Contract Name
 Madison Police Department Training Center - Phase 1

Date 9/1/2011
 Change Order No. CO 4
 Contract No. 6660
 Project No. 53W1009
 Change Order Project No.

Change Order Description
 Overexcavate poor soil conditions under concrete footing area and install clear stone foundation base material and install concrete grade beam.

To: Mr. Joe Daniels, President Joe Daniels Construction 919 Applegate Road Madison, WI 53713	Request No.: GC 2
Project: Madison Police Training Center	Contract for: General Construction
Owner: City of Madison PROJ. #53W1009, CONTRACT#6660 5702 Femrite Drive Madison, WI 53718	Initiation Date: 6/17/2011
	Response Date:
	Architect's Project No.: 46451

NEW TO EXISTING FOUNDATION CONNECTION DETAIL

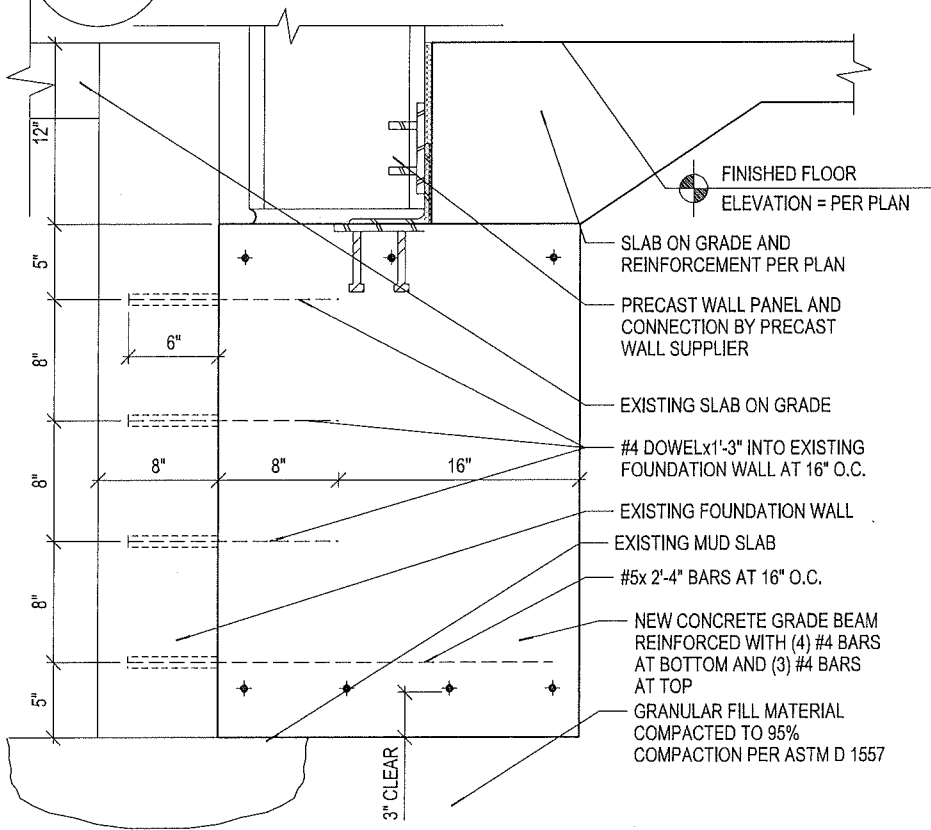
Request: 23/S105 New To Existing Foundation Connection Detail
Replace existing detail with attached revised SKS01 detail. Revised detail shall be between column lines D and M. Step new foundation wall to match step in existing foundation wall. At the step in the foundation wall, keep top and bottom dowels spaced at 5" from top and bottom of wall, the two remaining dowels shall be equally spaced.
RFP #2-A
